Subject: **Bid No. 8640-J6 – Generator Replacement – Mckeon Rd. Fire Station / WFD**

**ADDENDUM NO. 3**

PROJECT NAME  
**WORCESTER FIRE DEPARTMENT  
 WORCESTER  
 MCKEON ROAD FIRE  
 STATION  
 GENERATOR  
 UPGRADE**

SHEET NUMBER  
**E300**

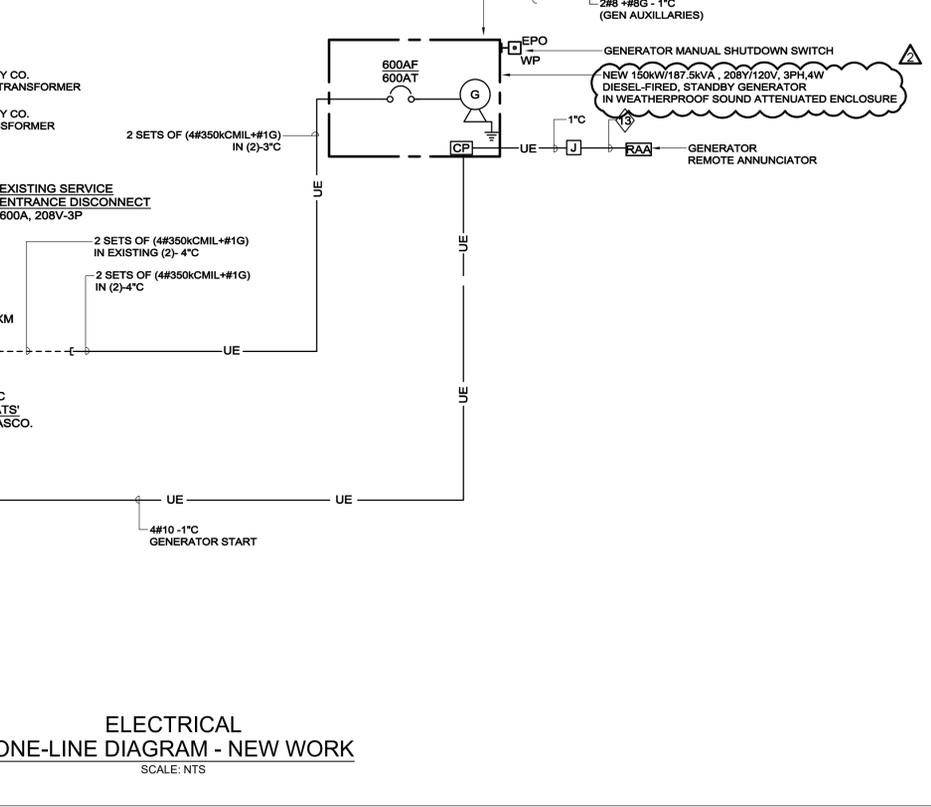
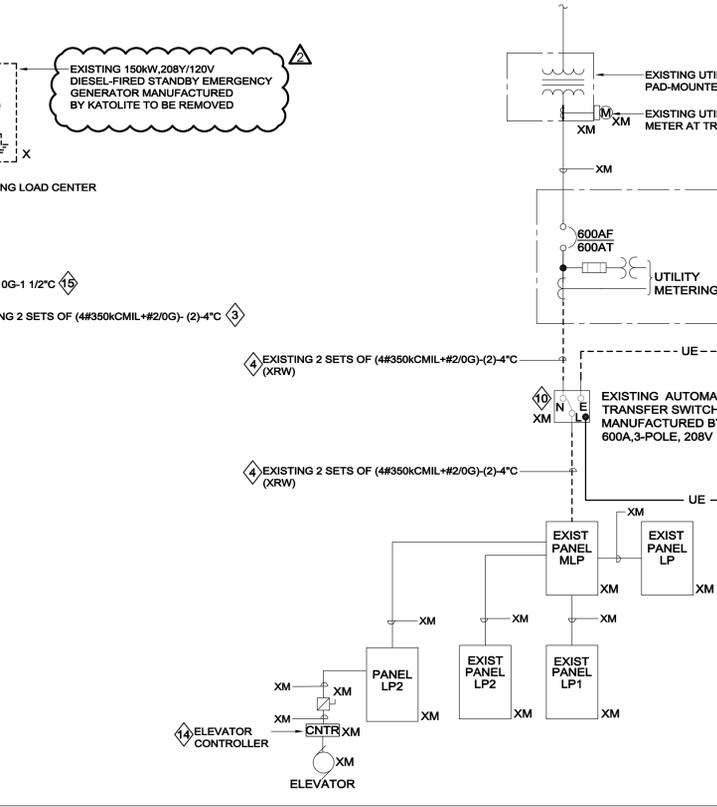
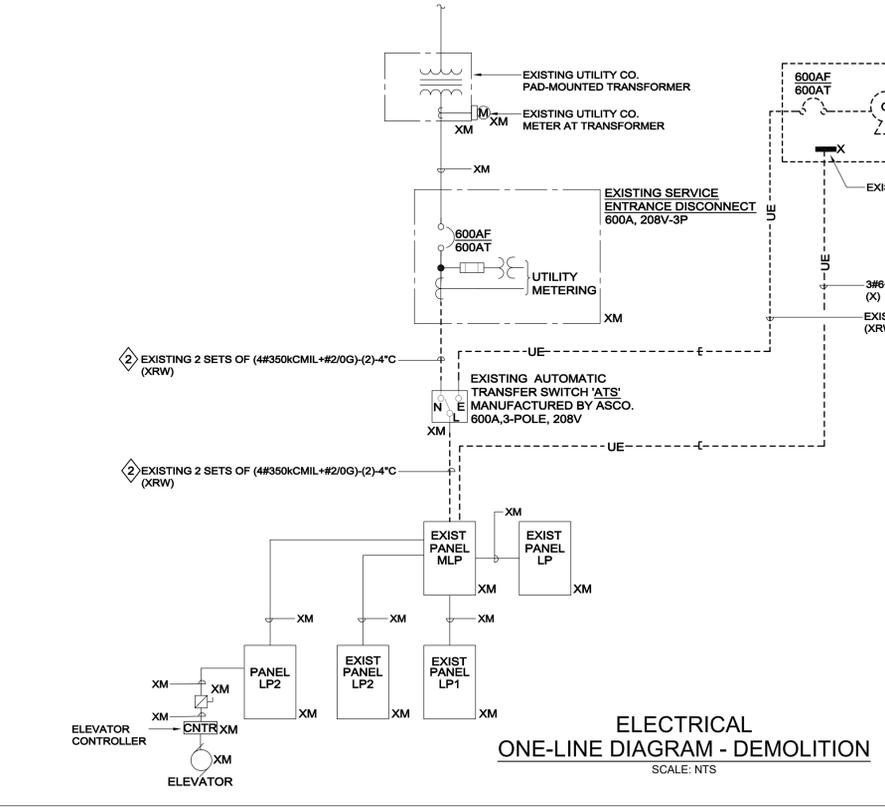
**1.1** Drawing No. E300:

Electrical One Line Diagram: Change 150kW/187.5kVA 208Y/120V, 3ph,4w natural gas generator to 150kW/187.5kVA, 208Y/120V diesel-fired generator.

SHEET NUMBER  
**E301**

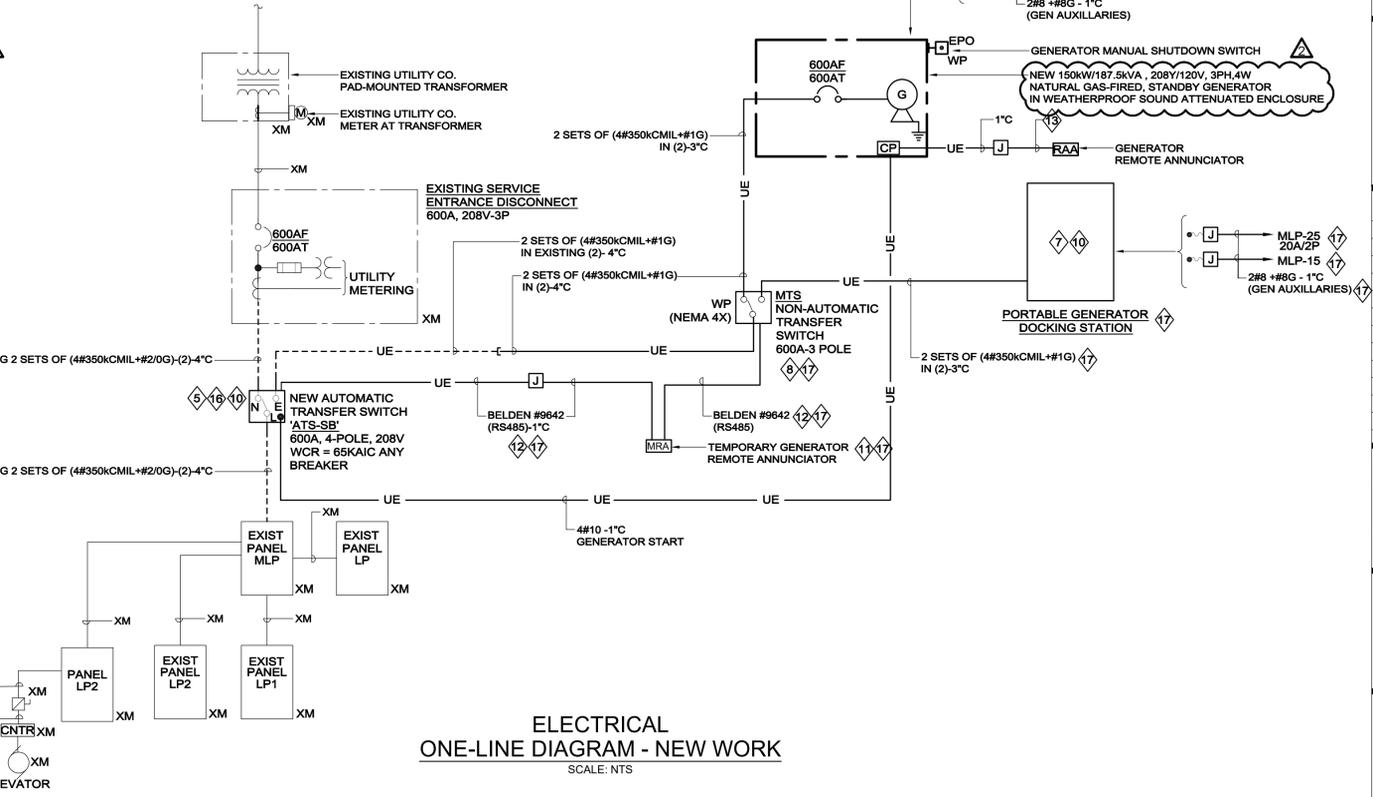
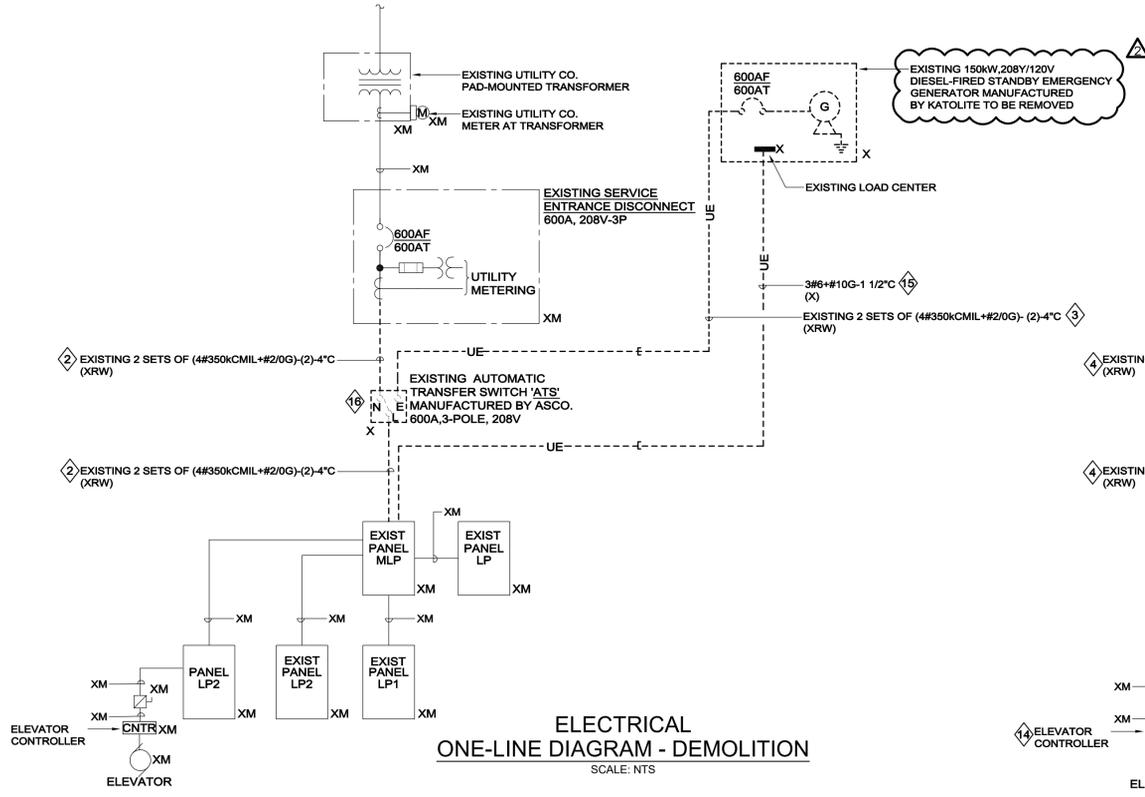
**1.2** Drawing No. E301:

Electrical One Line Diagram Add Alternate: Change 150kW/187.5kVA 208Y/120V, 3ph,4w natural gas generator to 150kW/187.5kVA, 208Y/120V diesel-fired generator.
